# 1967 Speed Control Installation Instructions

Kit Number 0722-94818-B

#### ADDENDUM TO I.S. NO. 2637

Note on Sheet No. 7 of 7 should be clarified as follows:

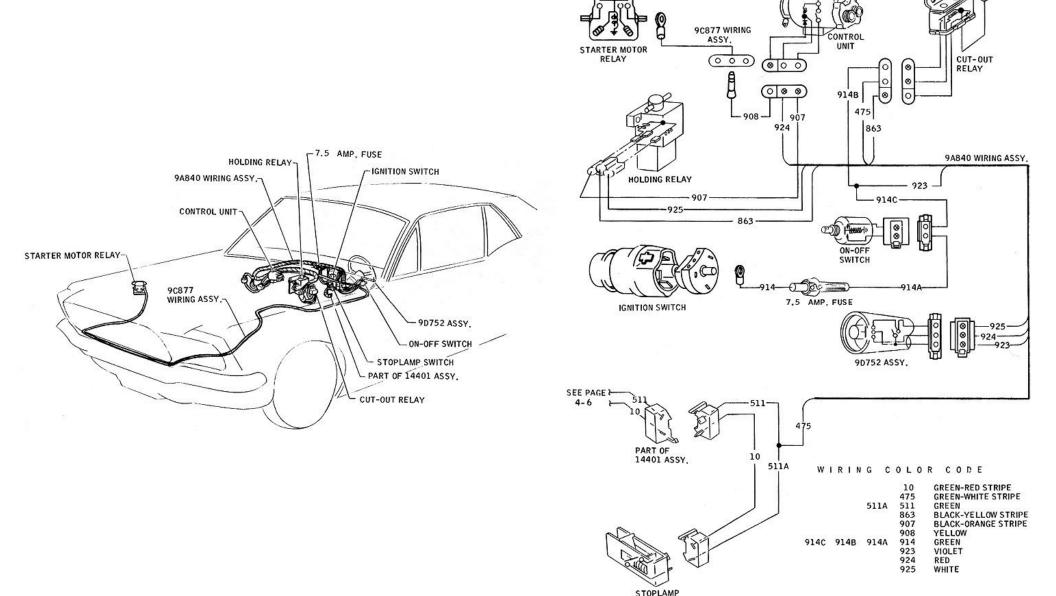
On early production vehicles equipped with tilt column, procure bracket C7ZZ-3F547-A and relocate tank as shown. On factory air conditioning equipped vehicles, procure tank assembly C7ZZ-19A566-A and install as shown. On vehicles with both air conditioning and tilt column, procure both tank assemblies C7ZZ-19A566-A and C7ZZ-3E547-A and bracket C7ZZ-3F547-A and install as shown. Also on 390 engine installations, check tank installation under battery, tray to insure clearance to engine.
